# Library Square, Ringsend

## Stage 1 Road Safety Audit

**Document Ref:** P23022-PMCE-XX-ZZ-RP-SA-RSA-3\_00\_01

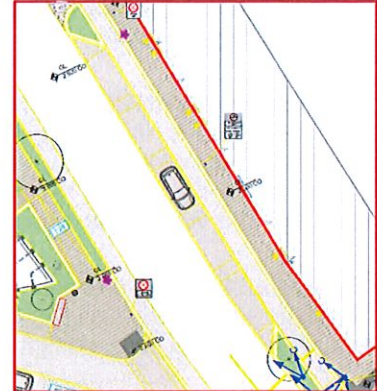
### 3.1 Problem

*Location: Parallel parking arrangements on Irishtown Road*

*Summary: The absence of an adequate buffer between the amended parallel parking spaces and the adjacent cycle lane may result in vehicle doors being opened into the path of a cyclist.*

It is proposed to reposition the existing parallel parking spaces along the eastern side of Irishtown Road and to position the cycle track to the rear of the parking spaces.

No buffer zone has been indicated between the parallel parking spaces and the adjacent cycle track, which could result in vehicle occupants opening their doors into the path of an oncoming cyclist.

An appropriate buffer zone should be provided between the cycle track and the parking spaces.

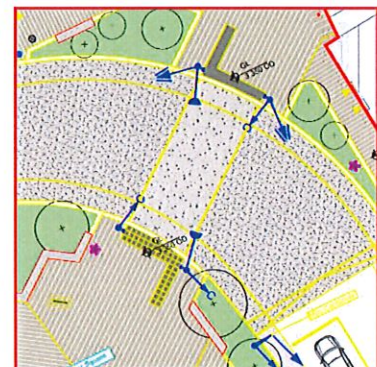
### 3.2 Problem

*Location: Proposed Toucan Crossing*

*Summary: Measures to advise visually-impaired pedestrians of the Shared Path on the approaches to/departures from the Toucan crossing have not been indicated.*

It is proposed to provide a new Toucan crossing on the corner between Bridge Street & Irishtown Road. This is likely to encourage cyclists to travel within the footpaths on either side of the crossing, in essence making the footpaths an area shared by both pedestrians & cyclists.

No measures have been indicated to advise visually-impaired pedestrians that they are entering an area shared with cyclists. This would lead to visually impaired pedestrians being insufficiently aware that they are entering a shared area where cyclists may also be present which could result in an increased risk of pedestrian-cyclist collisions.

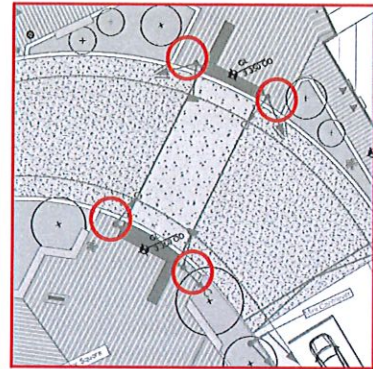
### 3.3 Problem

*Location: Proposed raised table between Bridge Street & Irishtown Road*

*Summary: Unclear if the raised table would be level/flush with the adjacent path.*

A raised-table is proposed on the corner between Bridge Street & Irishtown Road. It is unclear from the information provided if it is intended to provide a level difference between the path and the raised-table away from the proposed signalised pedestrian crossing.

Should there be insufficient level difference between the path and the raised-table, there is a risk that a visually impaired pedestrian may inadvertently enter the carriageway where there is an increased risk of being struck by a vehicle.

The proposed design should include measures to ensure that visually-impaired pedestrians do not inadvertently enter the carriageway at the proposed raised-table (e.g. providing an appropriate level difference between the footpath and the raised-table away from crossing locations).

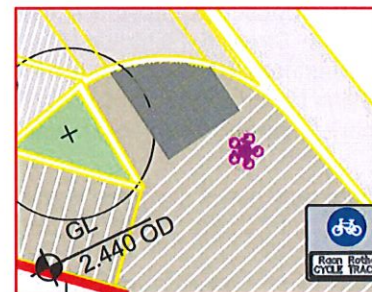
### 3.7 Problem

*Location: Fitzwilliam Street/Irishtown Road Junction*

*Summary: Position of lighting column may present a hazard to non-motorised road users (NMUs).*

A public lighting column is indicated centrally within the footpath on the southern side of the crossing of Fitzwilliam Street. This would present a hazard to inattentive or visually-impaired pedestrians travelling within the footpath.

Items of roadside furniture, including public lighting columns, should be positioned where they do not present an obstacle or a hazard to non-motorised road users within the footpaths.

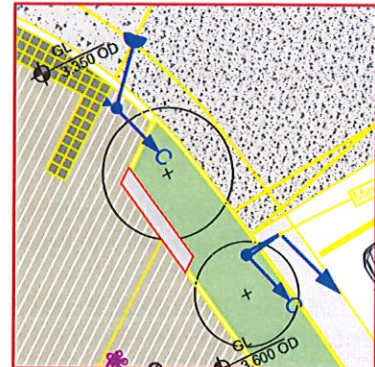
### 3.9 Problem

*Location: Cycle Lanes*

*Summary: Unclear if adequate vertical clearance would be available for cyclists within the cycle lane at all locations.*

Proposed trees have been indicated as extending over the cycle track/lane along Irishtown Road/Bridge Street at a number of locations. It is unclear at this early stage in the design process what the proposed tree species are, and if sufficient clearance/headroom would be available.

Insufficient clearance to the canopies could present a hazard to cyclists, or lead to sudden avoidance manoeuvres by cyclists resulting in possible loss-of-control incidents and personal injury.

Trees adjacent to, or overhanging, the cycle track should have a vertical clearance of 2.5m to the cycle track.

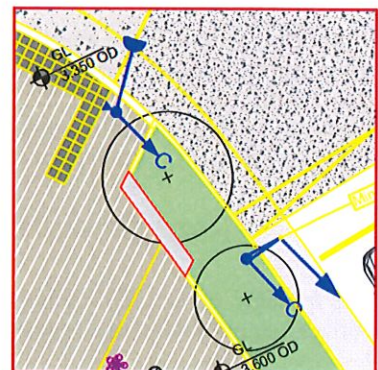
### 3.10 Problem

*Location: Proposed Cantilever Signal Supports at new Toucan Crossing*

*Summary: Unclear if the proposed cantilever signal supports at the new Toucan crossing will provide adequate clearance to cyclists within the cycle lane, and if measures are proposed to avoid them being struck by a vehicle that encroaches into the cycle lane.*

Cantilever signal supports posts have been indicated which overhang the proposed cycle lanes at a number of locations. It is unclear what the proposed clearance will be to the signals and their supports at these locations, and if insufficient they could present a hazard to cyclists, or lead to avoidance manoeuvres resulting in loss-of-control collisions.

In addition, no measures have been indicated to prevent vehicles from encroaching into the cycle lanes at these locations. Where a high-sided vehicle travels partially within the cycle lane there is a risk that they may strike the signals resulting in material damage.

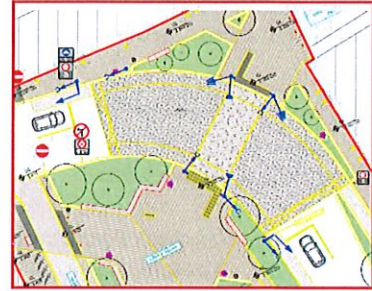
### 3.11 Problem

*Location: Irishtown Road/Bridge Street*

*Summary: Unclear if the swept path of two-way traffic can be accommodated within the amended road layout.*

Details of vehicle swept paths along Irishtown Road/Bridge Street have not been provided, and it is therefore unclear if two vehicles travelling in opposite directions can pass each other safely on the short radius horizontal bend between Irishtown Road & Bridge Street.

If there is insufficient space for opposing traffic to pass there is a risk of vehicles encroaching onto the cycle lanes and striking a cyclist, or side-swipe collisions between opposing vehicles.

A swept path analysis should be undertaken to confirm that the proposed road layout can accommodate the swept path of opposing vehicles safely at the short radius horizontal curve.

In addition, measures should be provided to ensure vehicles, in particular northbound vehicles, do not encroach onto the cycle lane through the bend.

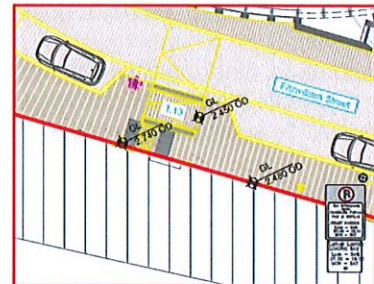
### 3.12 Problem

*Location: Fitzwilliam Street*

*Summary: Steep gradient within the footpath & carriageway.*

An 'external ramp' is proposed within the footpath on the western side of Fitzwilliam Street with a gradient of 1V:13H (c. 7.7%). The proposed ramp gradient may create difficulties for non-motorised road users. In particular a mobility-impaired wheelchair user, or someone pushing a pram, might fall forward out of a wheelchair when descending or the wheelchair or stroller may tip backwards when ascending.

In addition, at this early stage in the design process, it is unclear how the ramp will be implemented within the carriageway along Fitzwilliam Street. Should the gradient within the carriageway be similar to that within the footpath, and insufficient vertical curvature provided, there is a risk of vehicles "grounding" at the top of the ramp resulting in material damage.

The gradient on external ramps should not exceed 5% and an appropriate vertical alignment should be provided within the carriageway.

3.5	Yes	Yes		
3.6	Yes	No	The footpath will be kerb segregated from the road.	Yes
3.7	Yes	Yes		
3.8	Yes	Yes		
3.9	Yes	Yes		
3.10	Yes	Yes		
3.11	Yes	Yes		
3.12	Yes	No	The existing footpath ramp gradient is c. 26.3% (250mm rise across 950mm). It is proposed to provide steps and a ramp with gradient of 7.6%.  The vertical alignment within the carriageway at Fitzwilliam Street will not result in vehicle grounding.	Yes

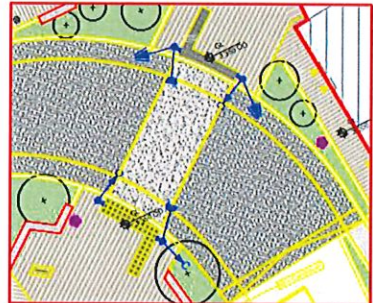
- 4.1 It is proposed to relocate the eastbound bus stop from the corner of Bridge Street & Irishtown Road onto Bridge Street. It is unclear from the information provided if it is intended to provide Kassel kerbs at the new bus stop.

The absence of Kassel Kerbs could create difficulties for the mobility-impaired, in particular wheelchair users, in accessing/leaving buses.
